Access Compliance Report

Public Rights-of-Way

Intersection ID: 10024504	Main Street: CRUMP_RD	Cross Street: N/A	Location: NW
ADA ID: 68AB9D33797F	Ramp Type: Perp	Initial Pass/Fail: Fail	Overall Compliance: No
		Severity Score: 10

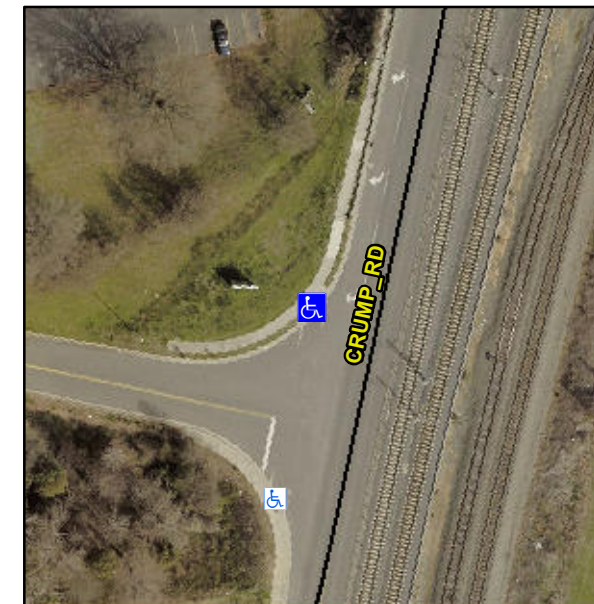
R304.5.1, R304.5.3

Compliance	Description	Data	Compliance	Description	Data
N/A	Ramp Length (in)	106.0	Yes	Ramp Slope (%)	6.0
No	Ramp Width (in)	47.5	No	Ramp XSlope (%)	2.8
N/A	Flare Type LT	N/A	N/A	Flare Type RT	N/A
N/A	Flare Slope LT (%)	N/A	N/A	Flare Slope RT (%)	N/A
N/A	Flare Traversable LT?	N/A	N/A	Flare Traversable RT?	N/A
N/A	Landing Length (in)	N/A	N/A	DWS Provided?	N/A
N/A	Landing Width (in)	N/A	N/A	DWS Contrast?	N/A
N/A	Landing Slope (%)	N/A	N/A	DWS Length (in)	N/A
N/A	Landing X Slope (%)	N/A	N/A	DWS Full Width?	N/A
N/A	Landing Curb? (Y/N)	N/A	N/A	DWS Offset (in)	N/A
N/A	Shared Landing?	N/A			
N/A	Gutter Ponding?	N/A	N/A	Gutter Slope (%)	N/A
N/A	Gutter Lip Ht (in)	N/A	N/A	Gutter X Slope (%)	N/A
N/A	Painted X Walk1?	Yes	N/A	Painted X Walk2?	N/A
	X Walk 1 Direction	To SW		X Walk 2 Direction	N/A
N/A	X Walk 1 Width (in)	112.0	N/A	X Walk 2 Width (in)	N/A
	X Walk 1 Slope (%)	1.2		X Walk 2 Slope (%)	N/A
	X Walk 1 X Slope (%)	2.5		X Walk 2 X Slope (%)	N/A

Remove & Replace Entire Ramp.
